Applies To: 1997 Prelude – Type SH

April 21, 1997

ATTS Heat Shield Rattle or Buzzing

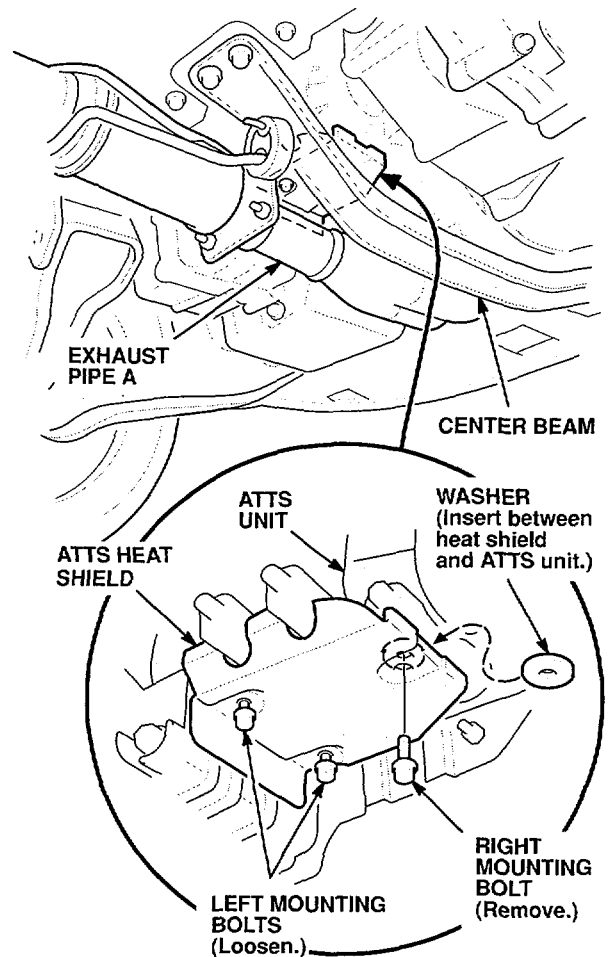
Insufficient clearance between the Active Torque Transfer System (ATTS) unit and the heat shield.

1. Raise the vehicle on a hoist.
2. Loosen the two left mounting bolts, and remove the right mounting bolt on the ATTS unit heat shield.

Increase the clearance between the ATTS unit and the heat shield with the washer listed under PARTS INFORMATION.

3. Insert the washer between the ATTS unit and the heat shield, then reinstall the right mounting bolt.
4. Torque all three mounting bolts to 9.8 N-m (7 lb-ft).
